Material Number & Description 642-1000-501 NOSE COWL, CFM56-5B	Serial Number 5809001	Originated By 500281	
Equipment 4000536430	Service Notification 500245510	QN Number 200344199	Insp. Lot 50000340070

Discrepancy Report

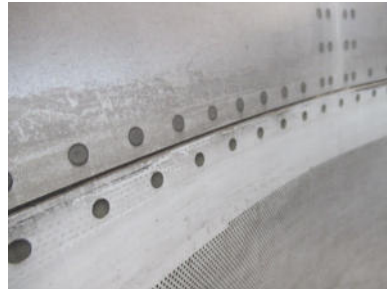
1.	MIC : E1050280 LIPSKIN SEGMENT: IPL 71-11-19-03-30 Discrepancy : C200 CORROSION   Corrective Action : 1. AAR2 REPAIR IAW SRM 54-01-01 PARA 2.A (ASSY) REPAIR IAW SRM 54-01-01 PARA 2.A Lip skin noted with minor scratches and minor surface corrosion throughout. 2. C48B INSPECT IAW NTM 51-10-04-PB4
2.	MIC : E1050290 LIPSKIN SEGMENT: IPL 71-11-19-03-40 Discrepancy : C200 CORROSION Corrective Action : 1. AAR2 REPAIR IAW SRM 54-01-01 PARA 2.A (ASSY) REPAIR IAW SRM 54-01-01 PARA 2.A 2. C48C INSPECT IAW NTM 51-10-04-PB4
3.	MIC : E1050300 LIPSKIN SEGMENT: IPL 71-11-19-03-50 Discrepancy : C200 CORROSION Corrective Action : 1. AAR2 REPAIR IAW SRM 54-01-01 PARA 2.A (ASSY) REPAIR IAW SRM 54-01-01 PARA 2.A 2. C48D INSPECT IAW NTM 51-10-04-PB4
4.	MIC : E1050000 CFM56-5B INLET COWL 642-1000-xxx Discrepancy : R312 REQUIRES SURFACE FINISH/PROTECTION

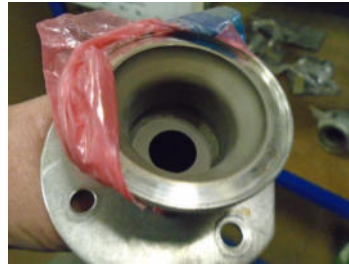
Discrepancy : W2B5 WORN PLASMA COATING
PLASMA COATING AND PROOF LEAK TEST REQUIRED

Corrective Action : 1. AAQ1 REPAIR IAW CMM 71-00-17 REP 014 OSP

Material Number & Description 642-1025-505 PANEL ASSY, INNER BARREL CFM56-5B	Serial Number N/A	Originated By 500281	
Equipment 4000536433	Service Notification 500245510	QN Number 200344197	Insp. Lot 50000340072

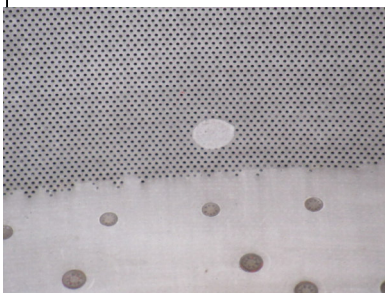
1.	MIC : E1050012 LWR ACOUSTIC PNL: 642-1025-517 Discrepancy : ZZZZ PREVIOUS REPAIR NOTED   Corrective Action : 1. ZZZZ NO ACTION REQUIRED Lower left acoustic panel noted with previous repairs at the 1.30 o'clock aft location 0.5" in diameter. Lower left acoustic panel noted with previous repairs at the 3 o'clock aft location 0.5" in diameter. Lower left acoustic panel noted with previous repairs at the 3.30 o'clock aft location 0.5" in diameter. Lower left acoustic panel noted with previous repairs at the 4 o'clock aft location 0.5" in diameter.
